Concerning regarding the future development of ECE R28

14.3.6

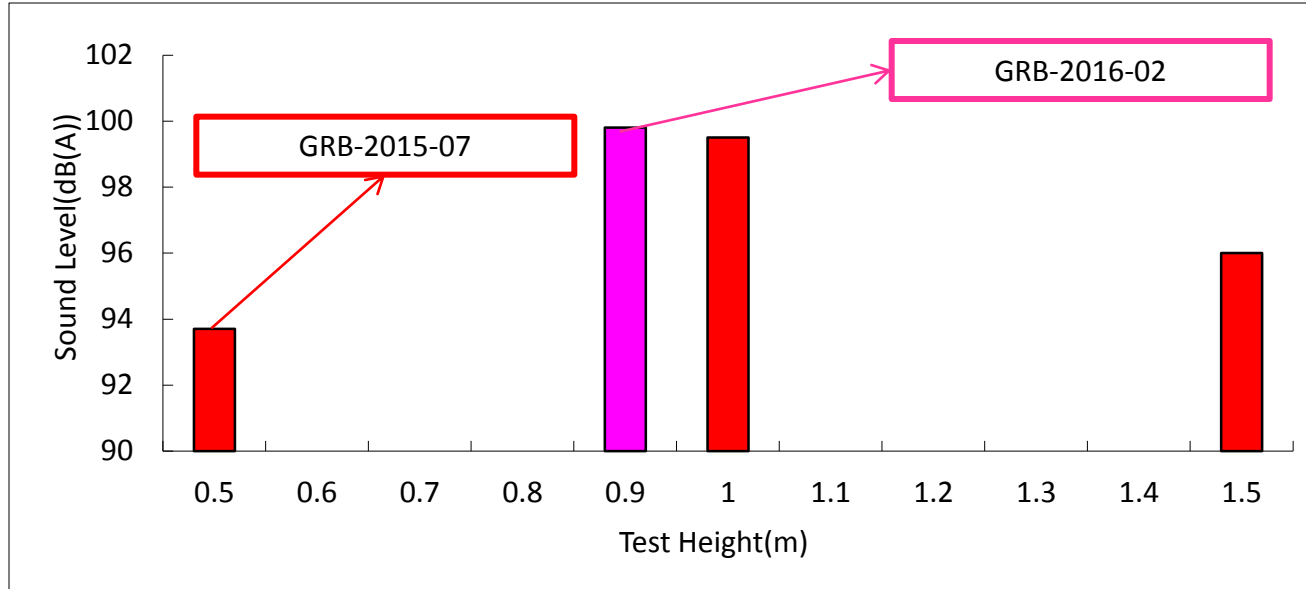
The A-weighted sound pressure level measurement is carried out at three points at the height of (0.5 ± 0.10) m, (1.0 ± 0.10) m, (1.5 ± 0.10) m. In each point three measurements shall be performed. The arithmetic average of all measurements at each point shall be rounded to the nearest whole number. The final result shall be the minimum value amongst the three arithmetic averages.

The differences of test results

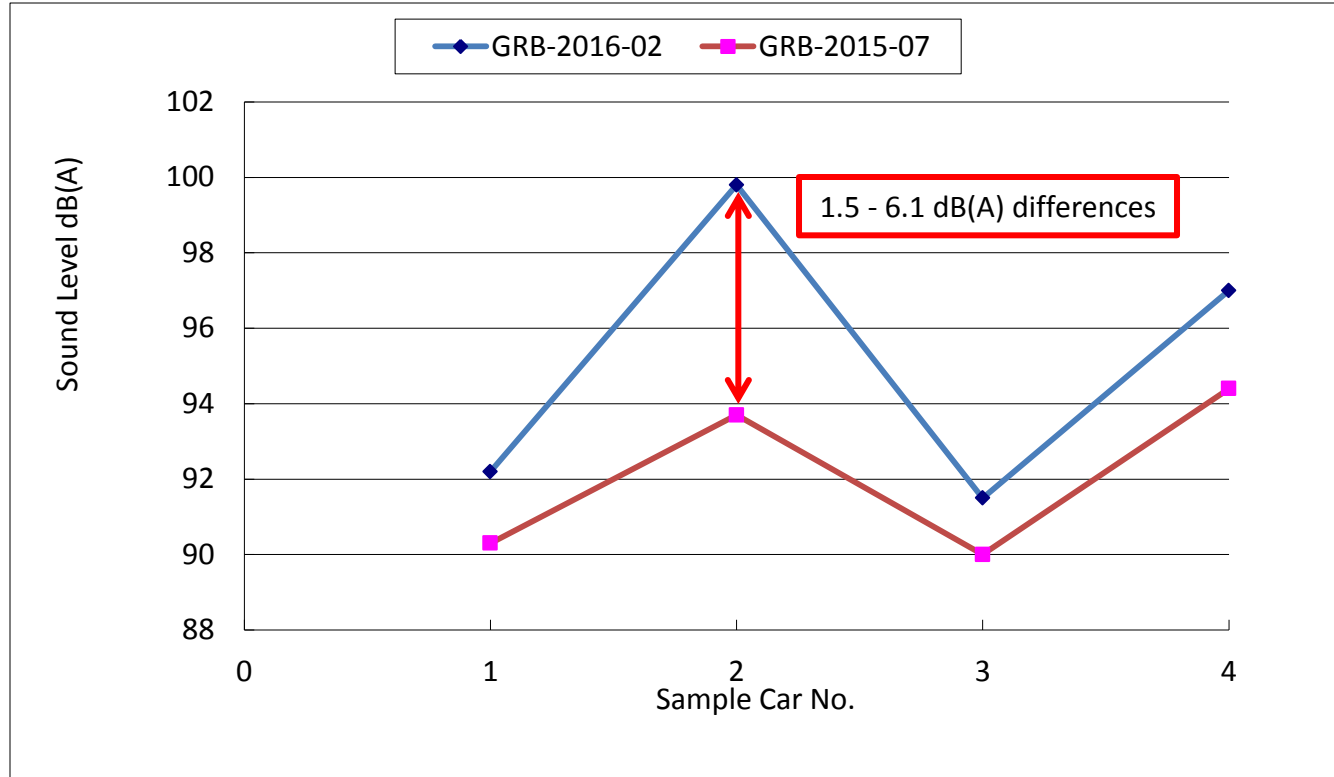
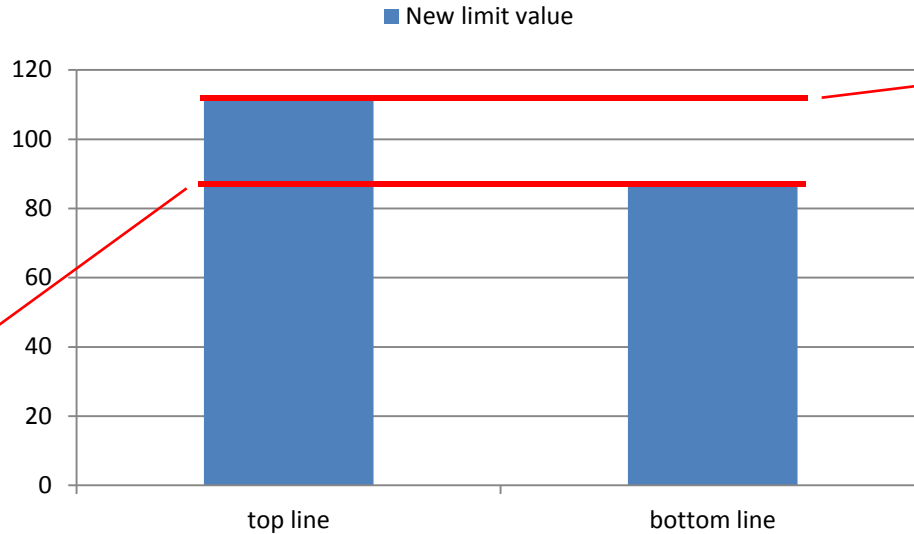
The differences of test results

For audible warning:

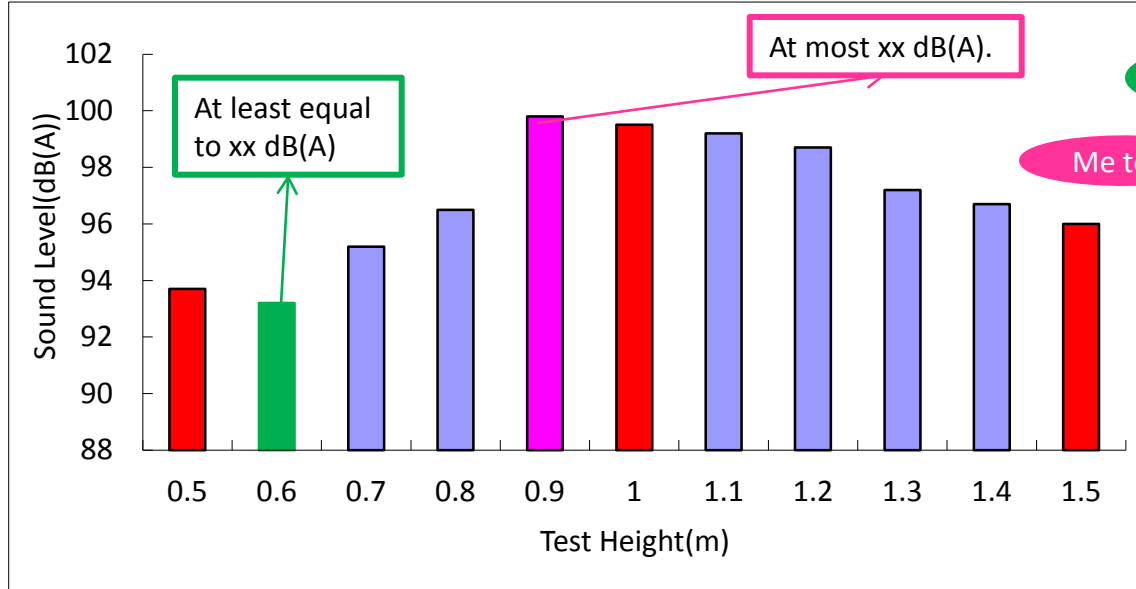
In the height between 0.5 to 1.5m, the minimum sound of the horn will not be lower than 87 dB(A), to make certain all people with different height can be warned.

In the height range between 0.5 to 1.5 m, the maximum sound of the horn will not be higher than 112 dB(A), to make certain the hearing of all people with different heights can be protected.
